**Subject: Vermont Yankee Nuclear Power Station
License No. DPR-28 (Docket No. 50-271)
Technical Specification Proposed Change No. 260
Intermediate Range Monitor Surveillance Test Frequencies**

Proposed Technical Specification Change No. 260

Intermediate Range Monitor Surveillance Test Frequencies

Marked-up Version of the Current Technical Specifications

TABLE 4.1.1

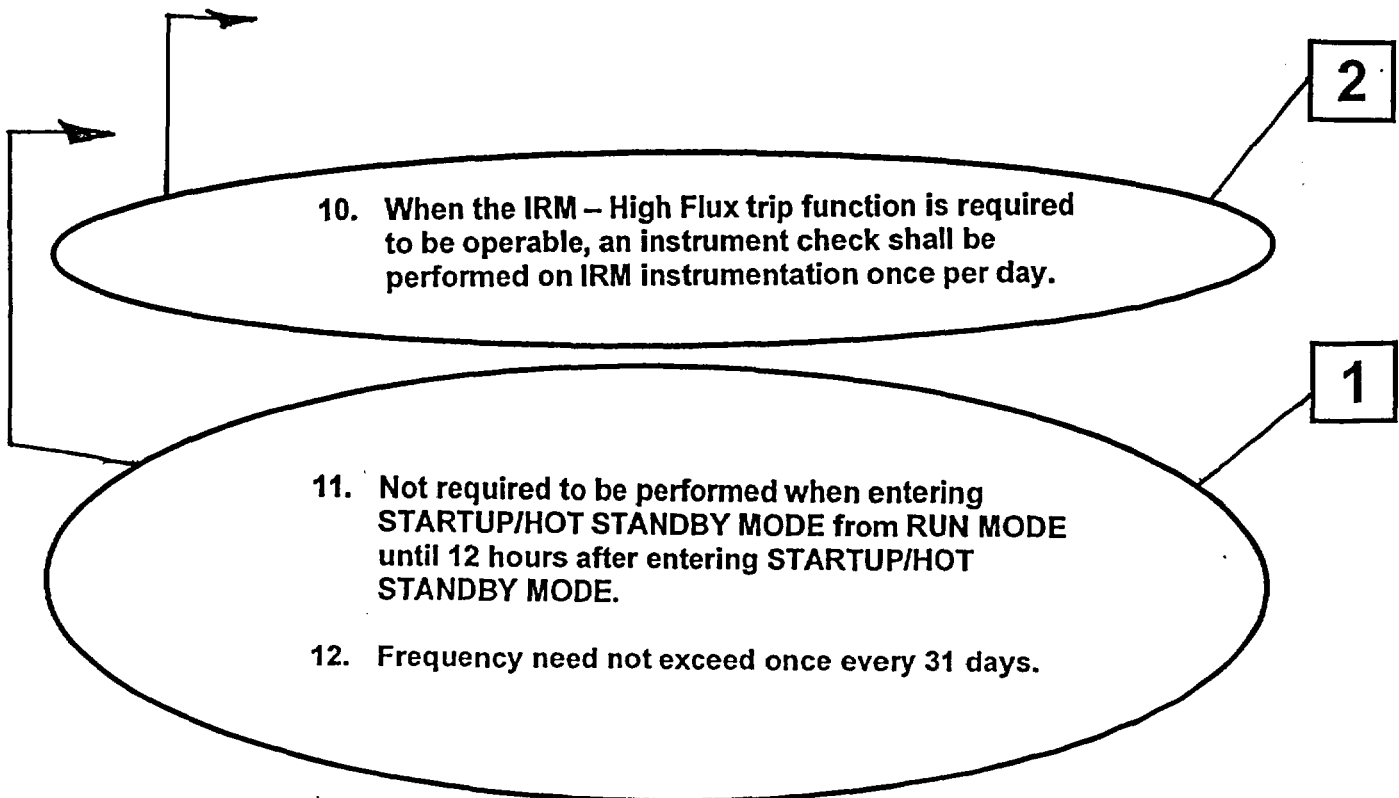
(10)

2

Before and During
Each Startup & Once
Every 31 Days During
Refueling^{(11) (12)}

1

10. When the IRM-High Flux trip function is required to be operable, an instrument check shall be performed on IRM instrumentation once per day.
11. Not required to be performed when entering STARTUP/HOT STANDBY MODE from RUN MODE until 12 hours after entering STARTUP/HOT STANDBY MODE.

12. Frequency need not exceed once every 31 days.
